# UNITED STATES PATENT AND TRADEMARK OFFICE

# Office Action Summary

10/784,037

## **DETAILED ACTION**

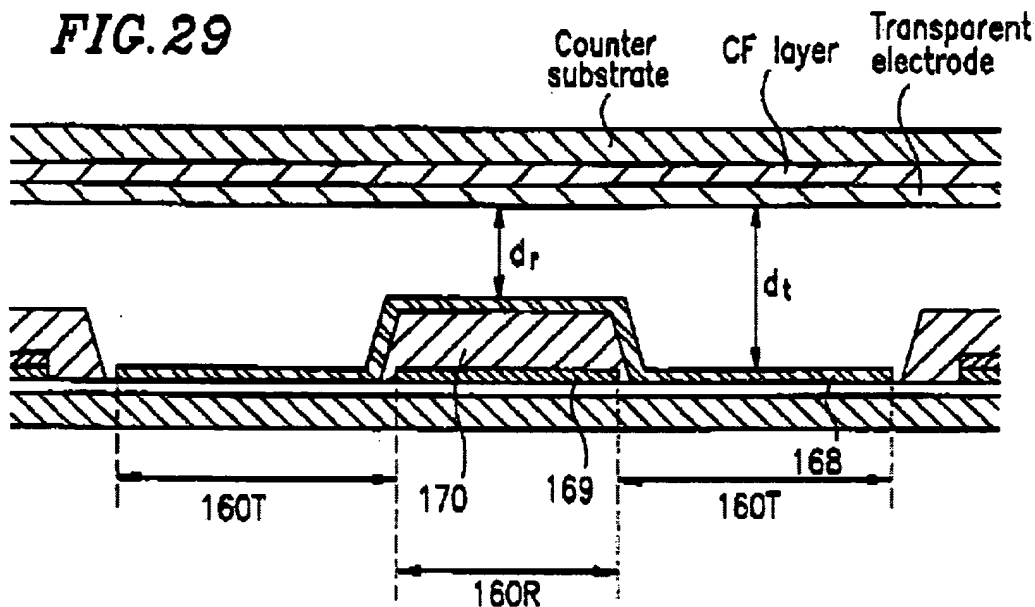
Claims 1, 2, 7-9, 11, 14-17, and 18 are rejected under 35 U.S.C. 103(a) as being unpatentable over Kubo et al (Kubo) USPAT 6,195,140 B1.

As to claims 1, 2, 8-9, 11, 15-17, and 18, Kubo discloses a transfective liquid crystal device [electronic apparatus, TFTs] comprising:

a light-reflecting layer, 169, overlapping reflective display regions in plan view in pixel regions and in a non-overlapping condition with transmissive display regions in the regions of the pixel regions other than the reflective display regions; and

a thickness-adjusting layer, 170, setting the thickness of the liquid crystal layer in the reflective display regions to be smaller than the thickness of the liquid crystal layer in the transmissive display regions; and

slopes are formed in the thickness-adjusting layer at a transition between each reflective display region and transmissive display region; and

edges of the light-reflecting layer adjacent the transmissive display regions are substantially aligned with bottom edges of the slopes of the thickness-adjusting layer [steep slope so reads on substantially aligned per Figure 29].

Kubo does not explicitly disclose that the second substrate of this device includes a shading film.

Kubo teaches that a black matrix is conventional for such displays [conventional black matrix are on the substrate opposite the reflective substrate] and that reduction or elimination of said black matrix is optional [col. 12, lines 36-46] to improve display brightness.

**FIG. 5D**

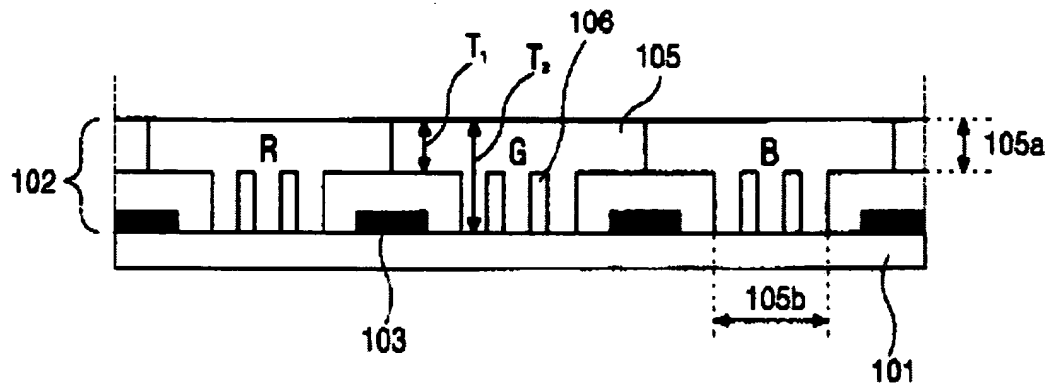
Kim teaches the use of reflective-display color filters in the reflective display regions and transmissive-display color filters [col. 8, lines 5-25], which are colored more strongly than the reflective-display color filters, in the transmissive display regions [strength of color is set by thickness and by presence of non-colored material 106] to avoid an unwanted difference in color purity between the reflective and transmissive portions of the display [col. 4, lines 1-20].

Kim is evidence that workers of ordinary skill in the art would find the reason, suggestion, or motivation to add of reflective-display color filters in the reflective display regions and transmissive-display color filters, which are colored more strongly than the reflective-display color filters, in the transmissive display regions to avoid an unwanted difference in color purity between the reflective and transmissive portions of the display.
